DESIGN <i>BS</i>	DRAWN BY <i>BS</i>	DART AEROSPACE LTD HAWKESBURY, ONTARIO, CANADA		
CHECKED <i>PH</i>	APPROVED <i>HH</i>	DRAWING NO. DSI 9350	REV. A	SHEET 1 OF 2
DATE 06.08.22	TITLE INLET/OUTLET ADAPTERS RELOCATION NTS			SCALE
A	06.08.22	NEW ISSUE

DART SERVICE INSTRUCTION

TO AMEND INSTALLATION INSTRUCTIONS IIN-D206-746 REV.A

REF. CANADIAN STC: SH05-45 ISSUE 1

RELOCATION OF D3478-041 AIR INLET ADAPTER

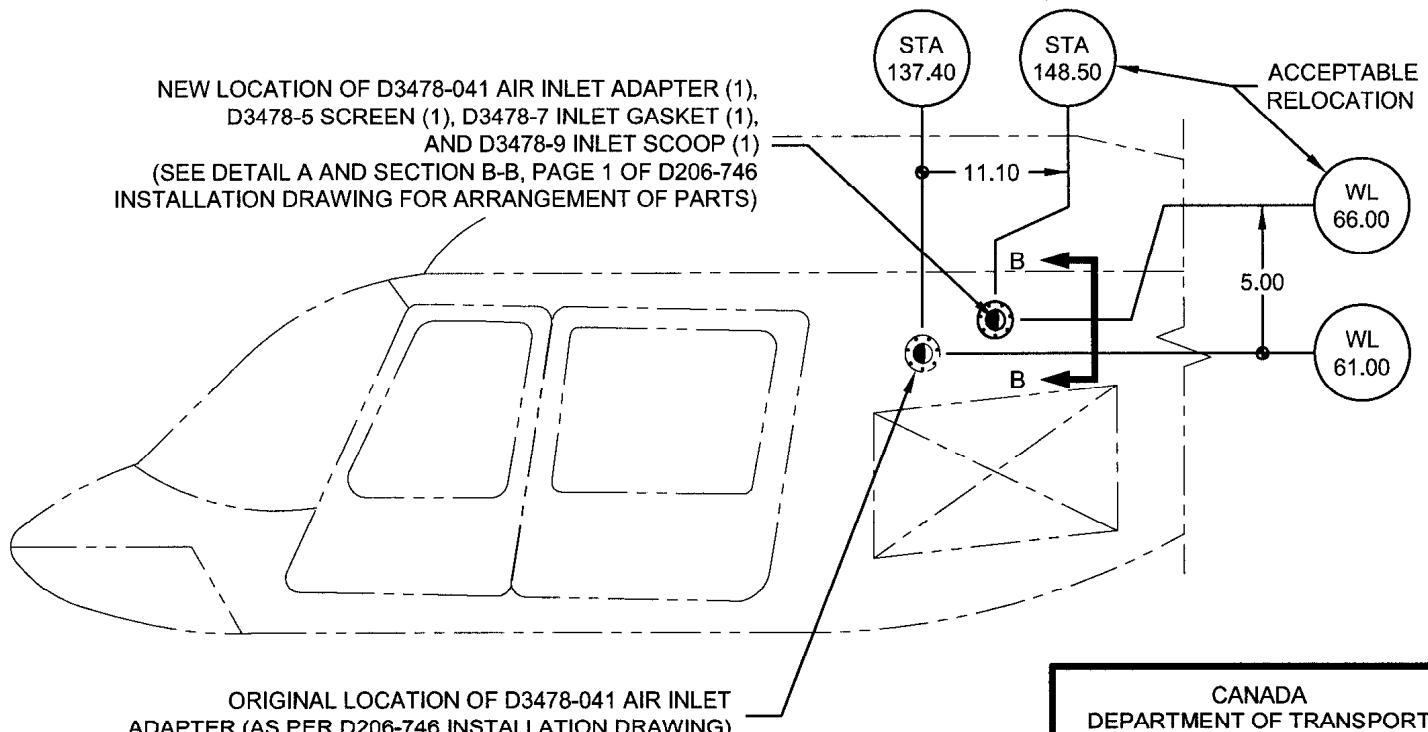
IT IS ACCEPTABLE TO CHANGE THE LOCATION OF THE D3478-041 AIR INLET ADAPTER FROM STA 137.40 AND WL 61.00 (SEE D206-746 INSTALLATION DRAWING PAGE 1) TO STA 148.50 AND WL 66.00 AS SHOWN BELOW.

IT MIGHT BE NECESSARY TO TRIM THE SCHEET THAT CONNECTS FROM THE D3478-041
INLET ADAPTER INSTALLATION TO D3469-041 SHUT-OFF VALVE ASSEMBLY.

RELOCATION OF D3475-041 DUMP OUTLET

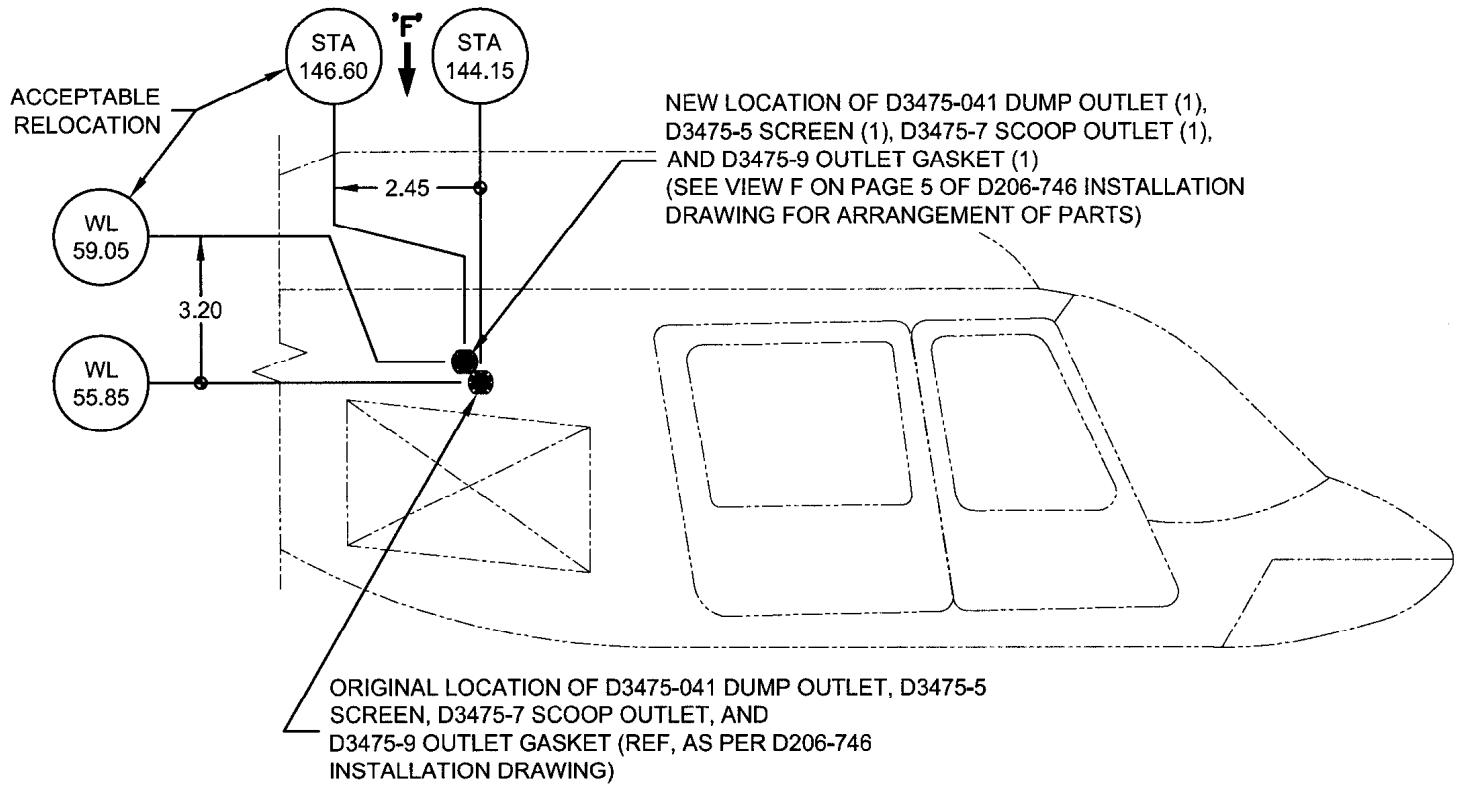
SIMILARLY, IT IS ACCEPTABLE TO CHANGE THE LOCATION OF THE D3475-041 AIR OUTLET ADAPTER FROM STA 144.15 AND WL 55.85 (SEE D206-746 INSTALLATION DRAWING PAGE 5) TO STA 146.60 AND WL 59.05 AS SHOWN BELOW.

IT MIGHT BE NECESSARY TO TRIM THE SCHEET THAT CONNECTS FROM THE D3475-041 DUMP OUTLET INSTALLATION TO D3473-041 BLOWER INLET ADAPTER.
